AIR - STG 10 TO HPT AIR VALVE - INTRODUCE THE IMPROVED SWITCH MECHANISM - CATEGORY
CODE 8 - MOD.ENG-75-0022

V2500-ENG-75-0022

AIR - V2500 SERIES ENGINES-STAGE 10 TO HPT VALVE ASSEMBLY, PART NUMBERS 5860010-103 AND 5860010-106. UPGRADE TO 5860010-108.

Figure 1

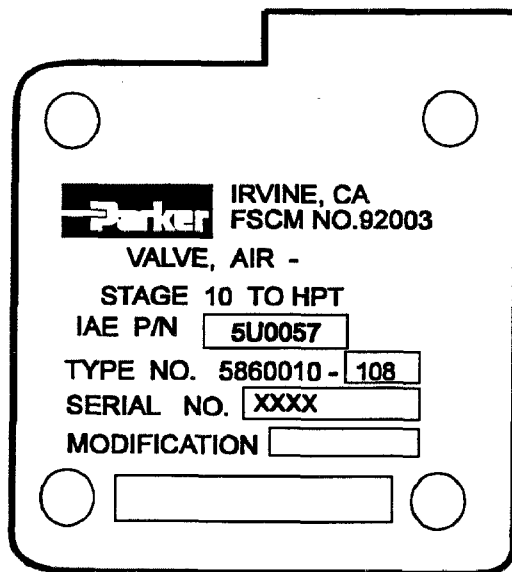
- D. Reidentification
- (1) Reidentify the Valve by using a 1/16 inch (1,59 mm) metal stamp in appropriate areas of the new nameplate as shown in Figure 1. The new IAE Part Number is 5U0057. The new Parker Part Number is 5860010-108. The serial number of the Valve remains the same for the -103 and -106 configurations.

- (2) Remove nameplate cover (5) in accordance with the DISASSEMBLY section of CMM, 75-23-51.
 - (3) Install new nameplate cover (5) in accordance with the ASSEMBLY section of CMM, 75-23-51.
